AMENDMENT
TO INSTALL
45 L.F. OF ACU
DRAIN
O.K. (GEL)

TRANSMITTAL SHEET
ENGINEERING & RESOURCE PROTECTION → STORMWATER

Project: Landmark Auto

County Plan No.: SP-051-02

RECORD DRAWING
 JCC-SP-0051-2002

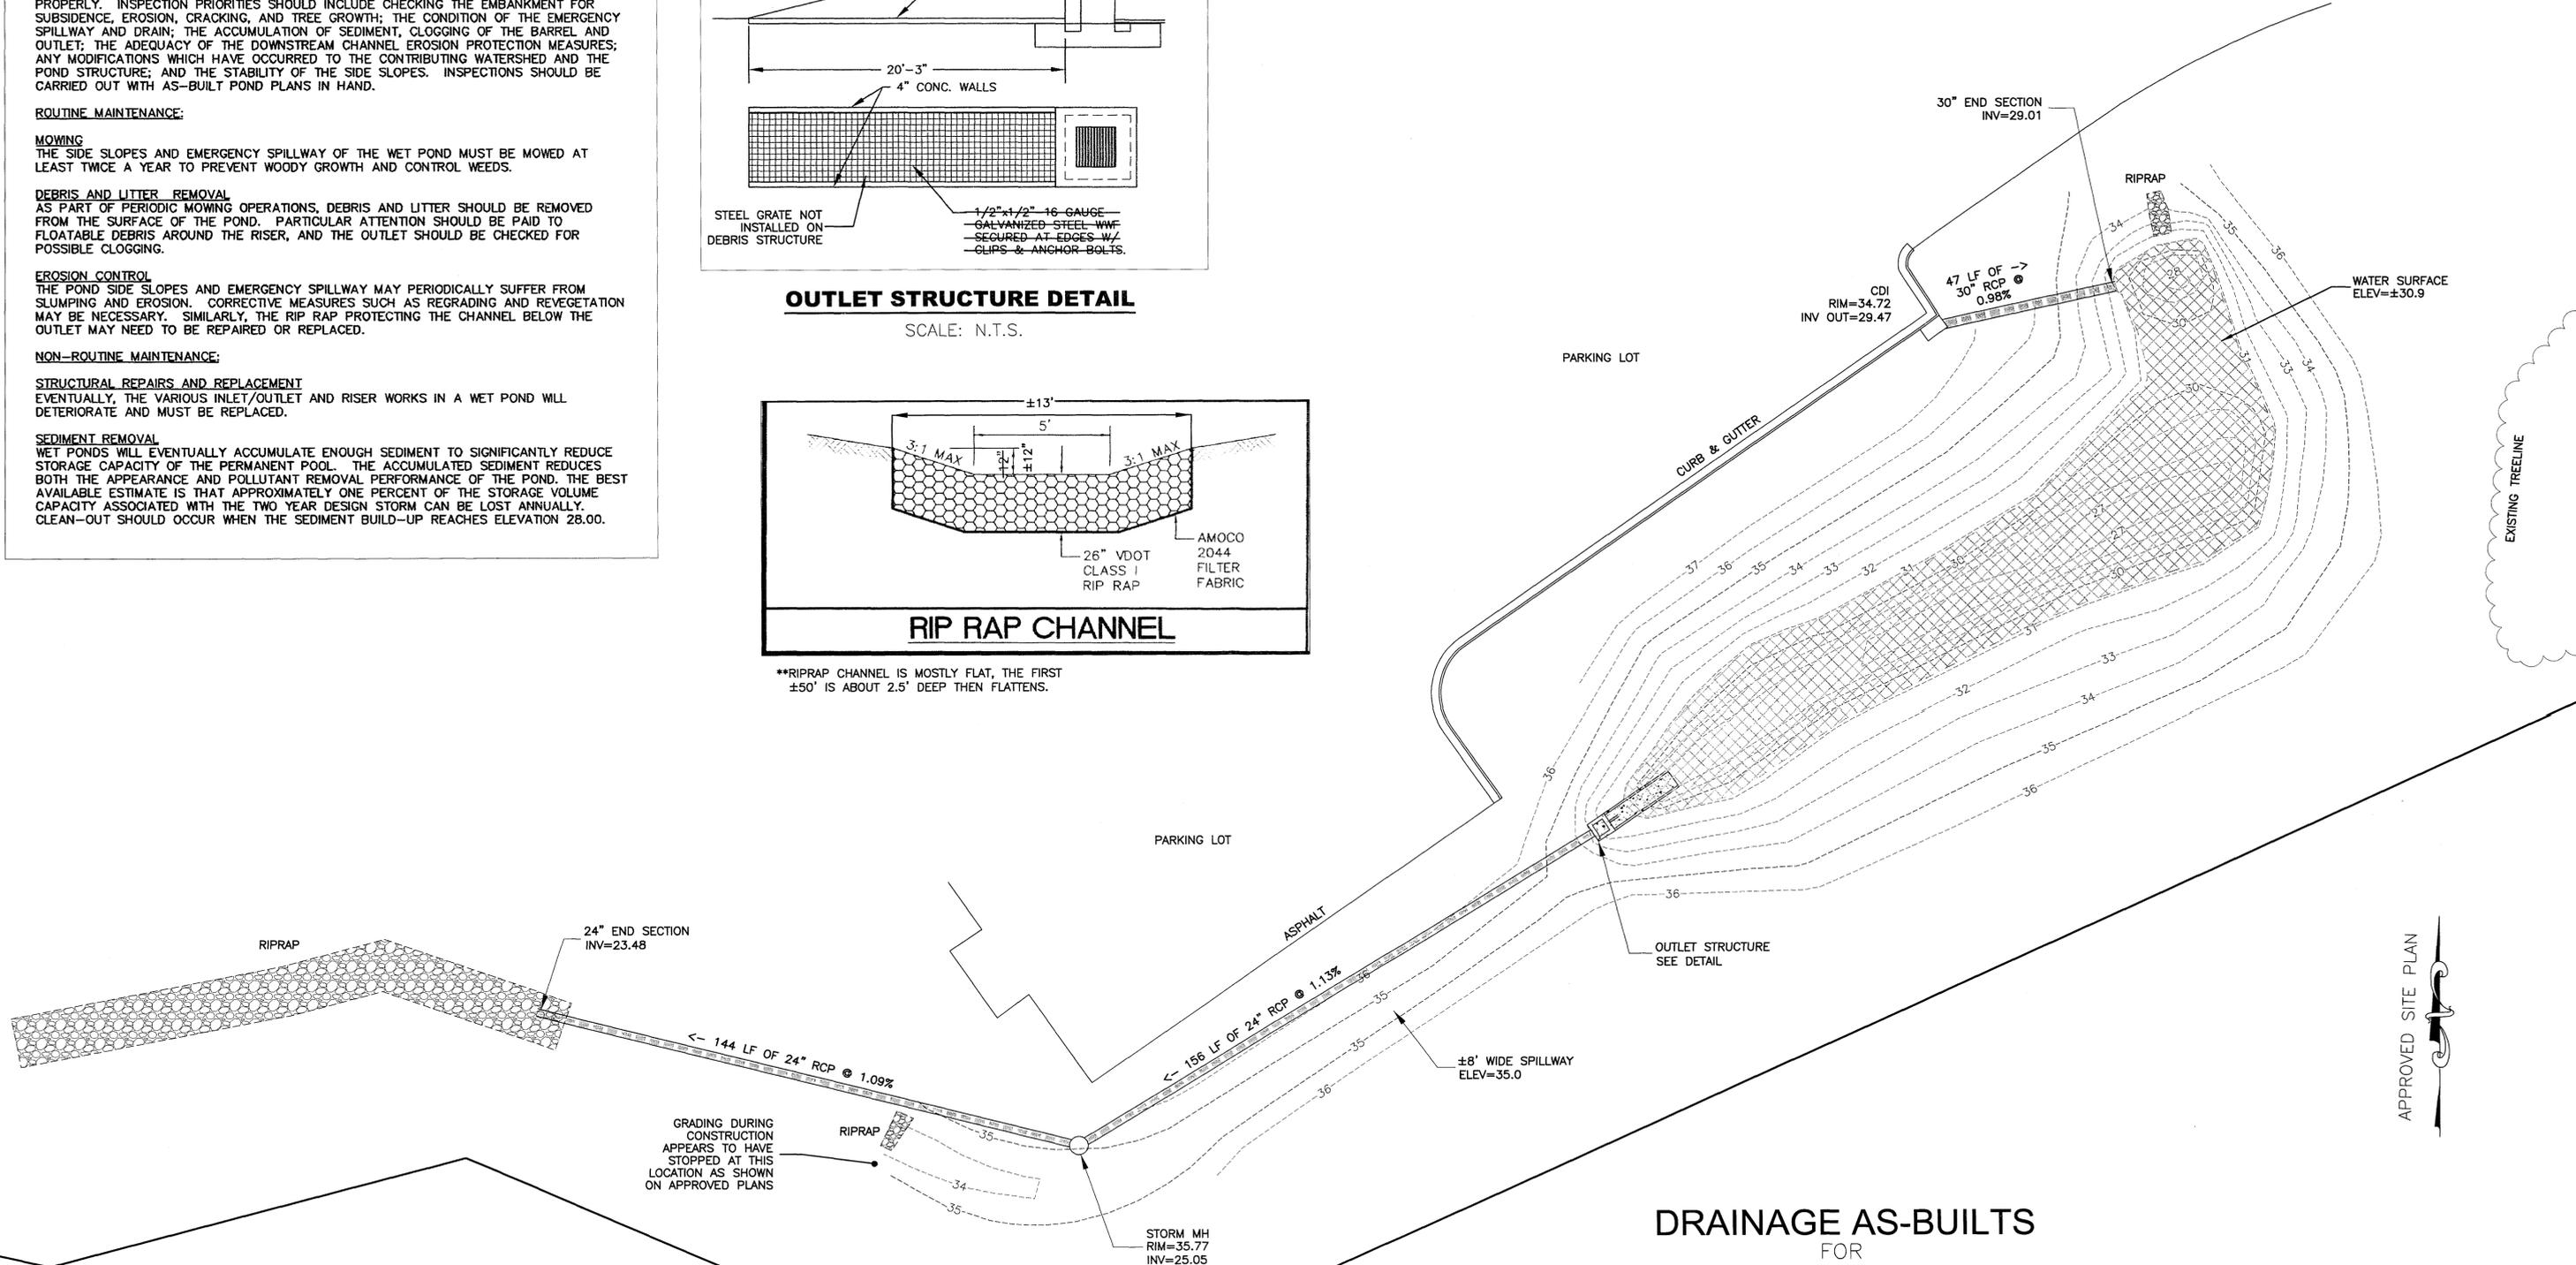
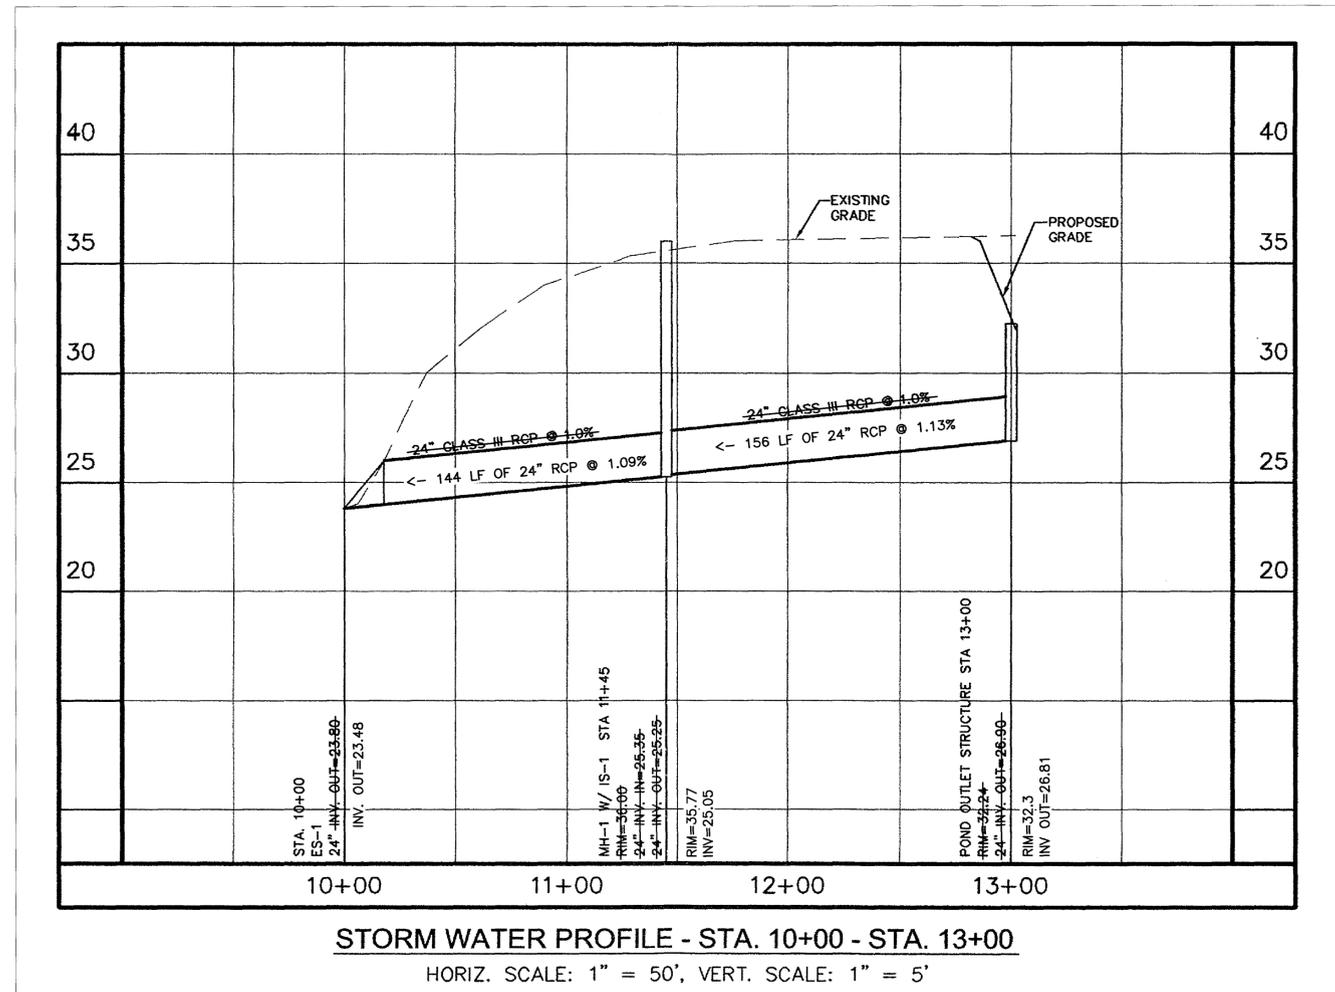
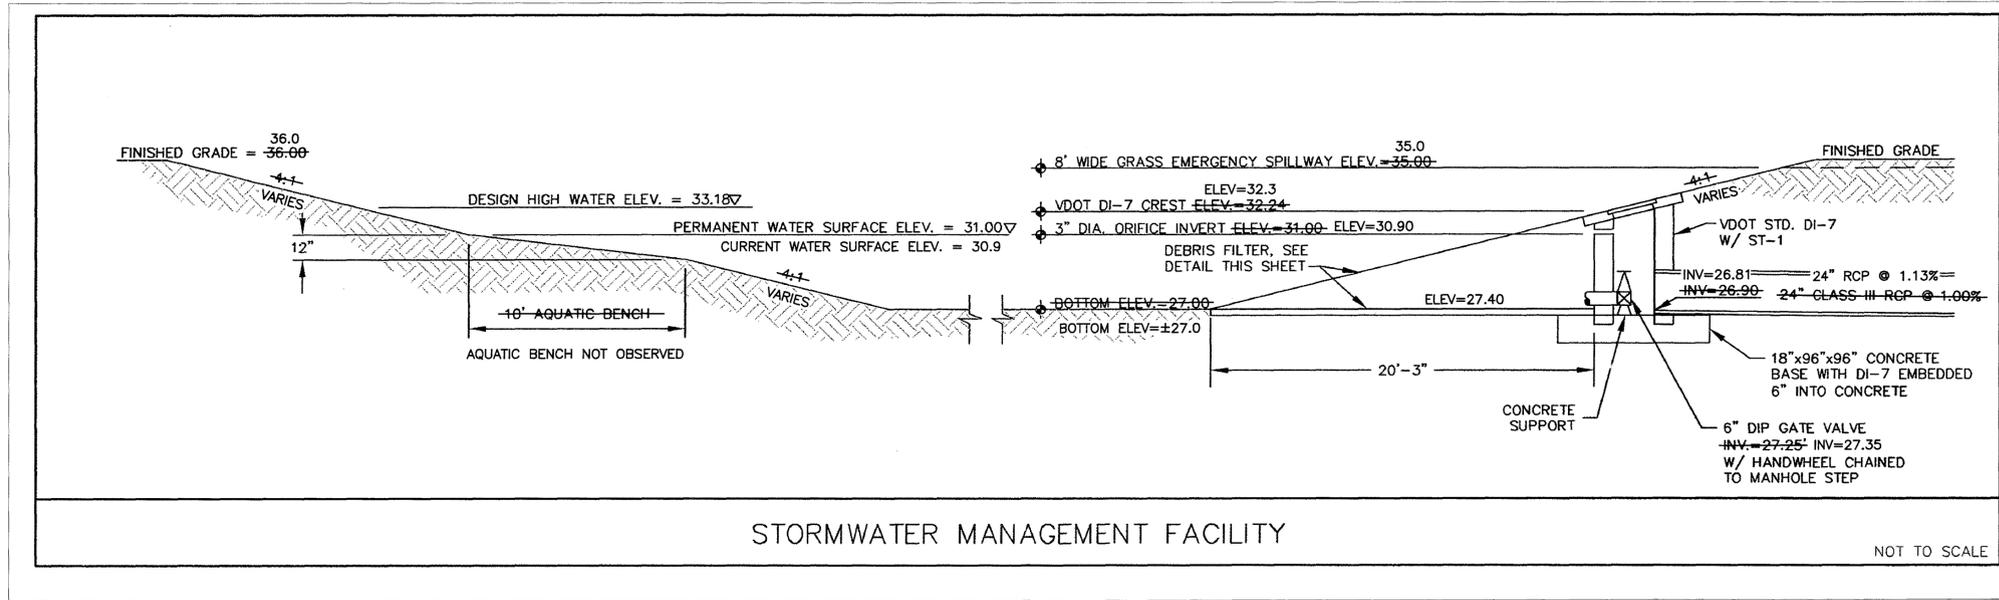
The record drawing set dated 11/23/04 is **not satisfactory**.

6. Show the following additional information on the record drawing: contour or elevation data; low flow orifice data, riser data, outlet barrel data; emergency spillway data; forebay data; and outlet protection data; property or road data.

7. Add the approved maintenance plan from Sheet C9 of the approved plan to the record drawing.
8. A professional seal and signature is required on the revised record drawing.

13. According to the record drawing, the pond was not built according to the approved plan. The permanent pool elevation is off and would apparently have a negative affect on water quality.
